5589

PARKING RATIO, MANEUVERING AND ACCESS, TREE PLANTING AND LANDSCAPING AREA VARIANCES TO ALLOW THE EXPANSION OF A CUSTOM PRINTING BUSINESS IN A B-2, NEIGHBORHOOD BUSINESS DISTRICT WITH 9 PARKING SPACES, AN 11-FOOT WIDE ONE-WAY DRIVE AISLE FOR TWO-WAY TRAFFIC, 1 FRONTAGE TREE, AND INSUFFICIENT LANDSCAPING AREA; THE ZONING ORDINANCE REQUIRES 16 PARKING SPACES FOR A 4,650 SQUARE-FOOT BUILDING, TWO-WAY DRIVE AISLE ACCESS AT LEAST 24 FEET WIDE, ADEQUATE MANEUVERING AREA, AT LEAST 12% OF THE BUILDING SITE TO BE LANDSCAPED, WITH 60% OF THE FIGURE LOCATED IN THE FRONTAGE.

157 DEXTER AVENUE

BOARD OF ZONING ADJUSTMENT

SITE PLAN

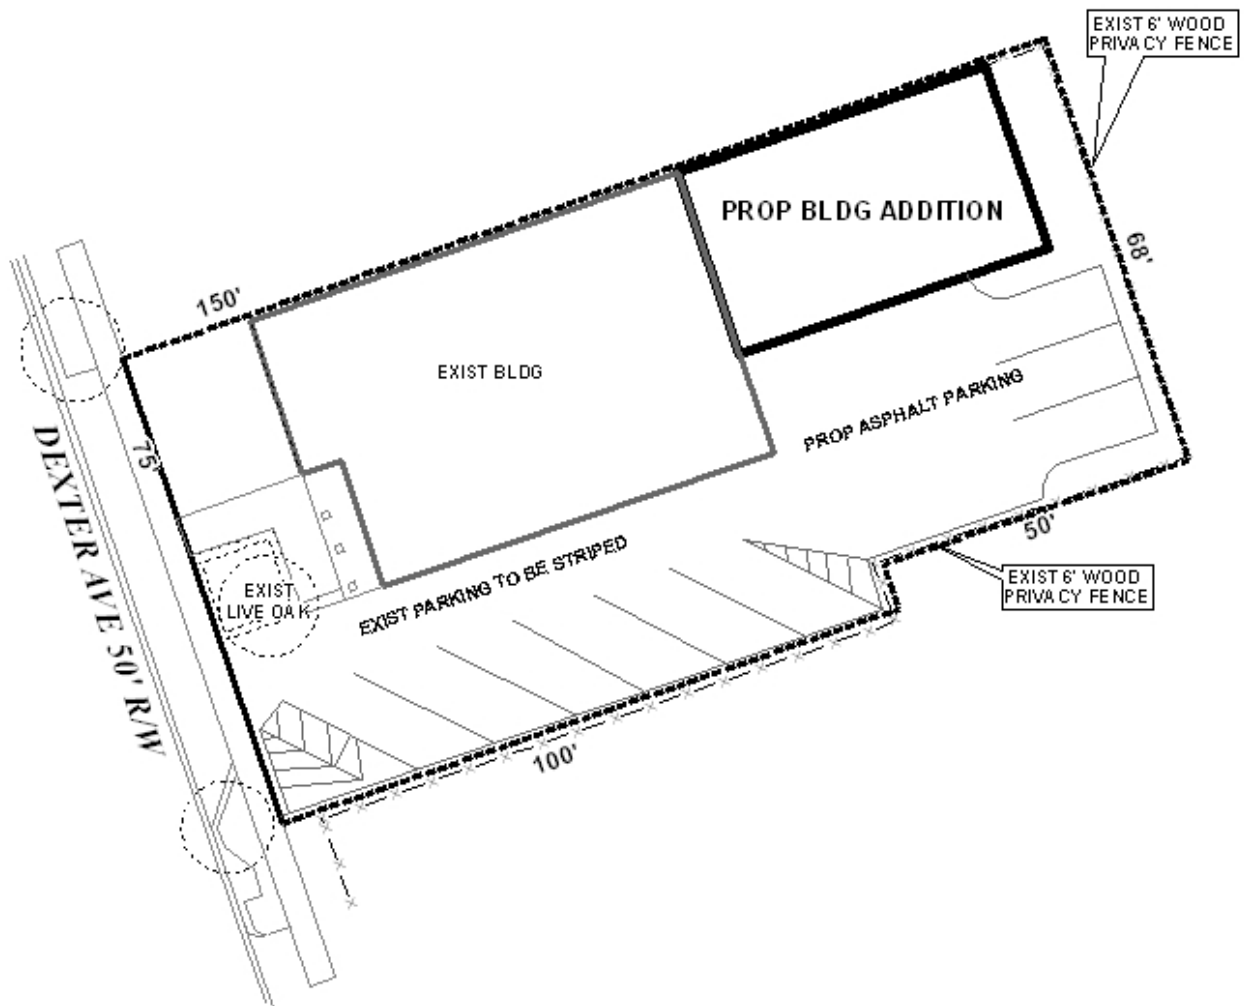
The applicant is proposing to construct an addition to the existing building, which is currently being used as a custom printing shop. There is already limited, insufficient space for parking and maneuvering on the building site, and a 48% building addition would further complicate the parking. The applicant proposes six parking spaces at a 45° angle off of an 11-foot wide two way aisle. Such a parking situation would effectively make the angled parking spaces useless.

The applicant has provided no justification in the narrative as to what, if any, hardship exists on the property. It is evident, however, that space on the site is limited. While ordinarily this could be considered a hardship, the Board must also consider the public interest. In this case, angled parking would render the spaces virtually unusable and would further limit the parking on the site.

The parking situation could be eliminated by providing four parallel parking spaces (20-foot length end spaces and 23-foot interior spaces as per City of Mobile Traffic Engineering) on the southern property line. By providing parallel parking spaces, the

drive aisle width would be significantly increased, and only two parking spaces would be lost. The applicant already states that there will only be four employees at the location, and a total of seven parking spaces should be sufficient to provide parking for employees and customers.

It should be noted that no dumpster is depicted on the site plan, and no information is given on refuse collection. Considering the limited space on the site, refuse collection should be limited to curbside pickup only. If, in the future, the applicant wishes to add a dumpster, a new review by the Board would be required.

- 1) The six 45° angle parking spaces on the South property line be eliminated and replaced with four parallel parking spaces (20-foot length end spaces and 23-foot interior spaces as per City of Mobile Traffic Engineering);
- 2) The site be limited to curbside garbage and trash pickup;
- 3) The site be limited to five employees at a time;
- 4) One heritage tree to be planted on the southern end of the property in the area not currently covered by the existing live oak's dripline;
- 5) Two copies of the revised site plan be submitted to the Planning Section of the Urban Development Department indicating compliance with all conditions prior to issuance of any permits; and
- 6) Approval from ARB for all improvements.
